FINAL DRAFT MINUTES

December 19, 2013 Standards Committee Meeting

RE: Minutes from the December 19, 2013 Standards Committee Meeting

STANDARD DRAWING NO. E 610-MBAP-01

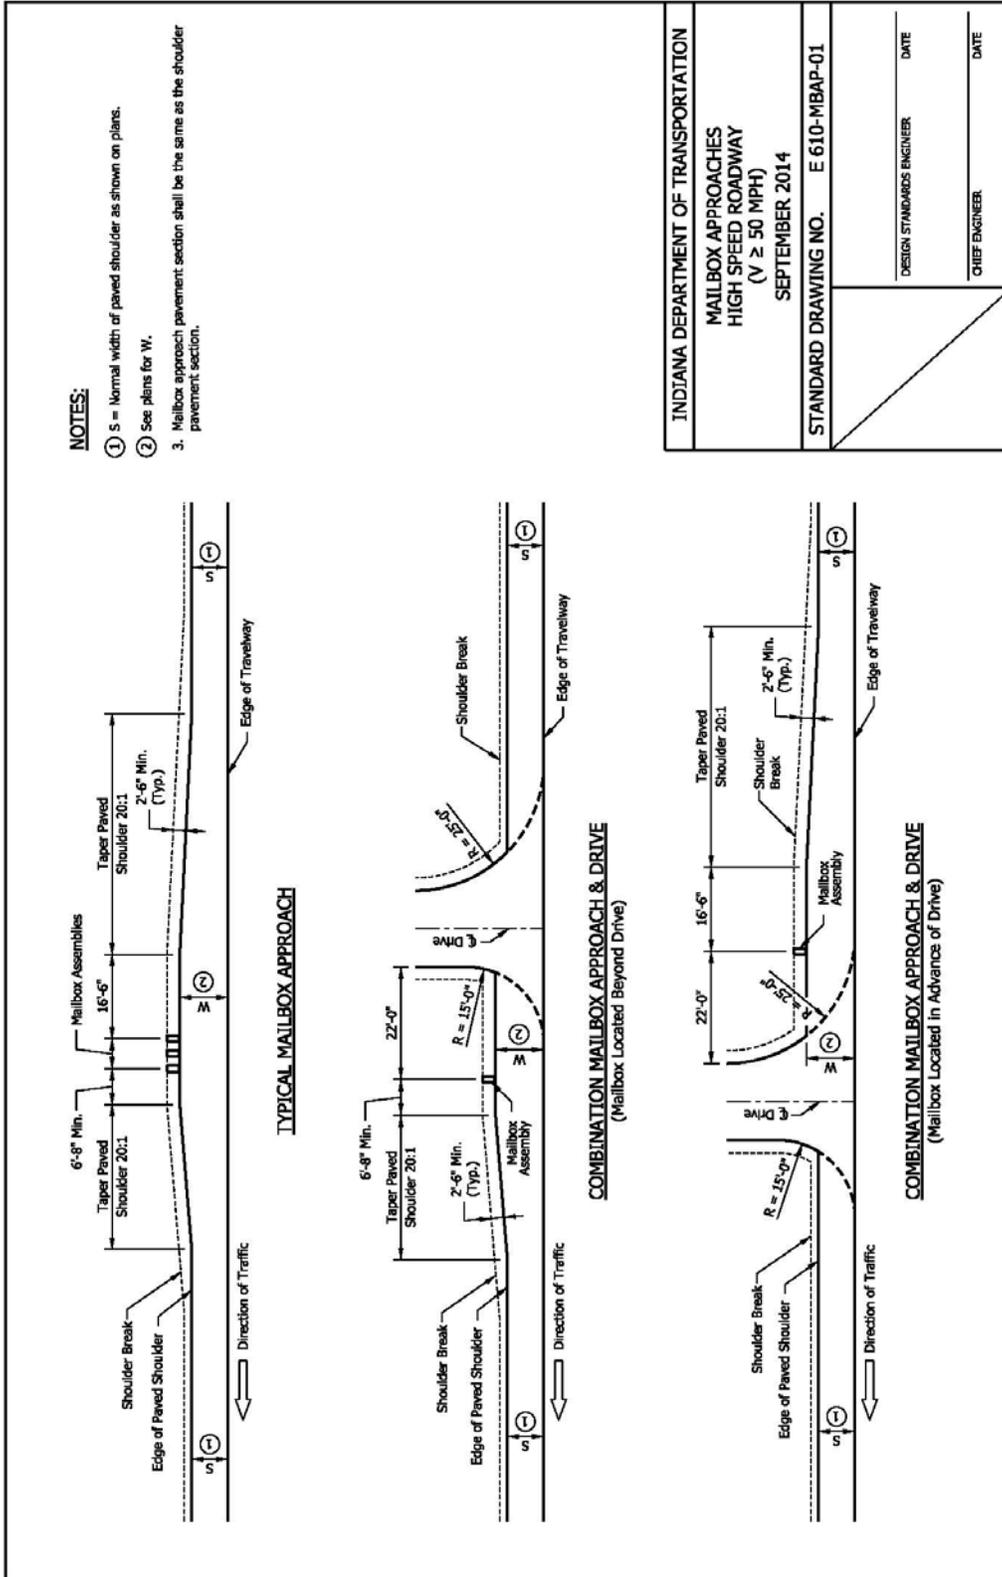
PROBLEM(S) ENCOUNTERED: Issues discovered related to the notes and drawing views on Standard Drawings 610-MBAP-01 and -02.

PROPOSED SOLUTION: See attached markups for proposed editorial revisions to Standard Drawings 610-MBAP-01 and -02. These revisions include correction of language in notes, correction of titles of drawing views (sheet -01), addition of text to drawing titles, update of drawing format and title blocks, addition of shoulder break (sheet -01) and callouts, and rearrangement of drawing views to show typical configuration first.

DISCUSSION: Mr. VanCleave introduced and presented this item explaining that the revisions to the drawings are editorial. The revisions include correction of language in the notes, corrections to the titles of drawing views, updating the drawing format and title blocks, as well as rearranging the drawing views for clarity.

609-RCBA-01 REINFORCED CONCRETE BRIDGE APPROACH SQUARE (REVISED DRAFT)

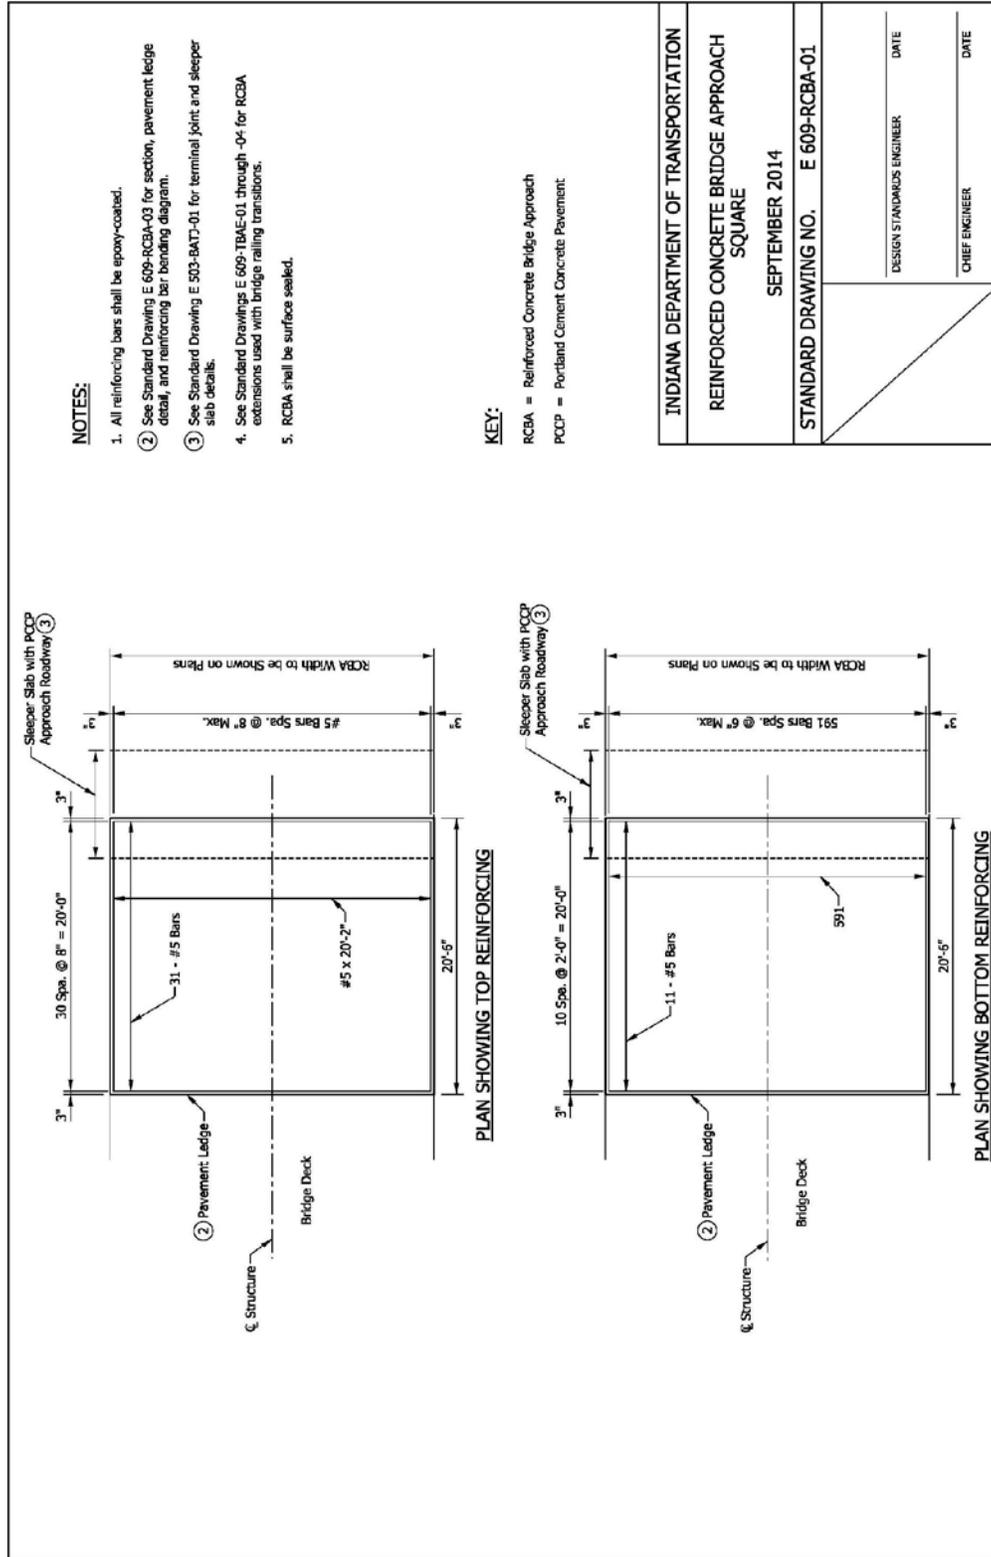
DISCUSSION: Ms. Phillips introduced and presented this item explaining that 609 and the attached standard drawings needed to be revised to include the use of threaded tie bar assemblies. Ms. Phillips addressed the highlights of the revisions presented, indicating the introduction of the threaded tie bars relating to constructability issues.
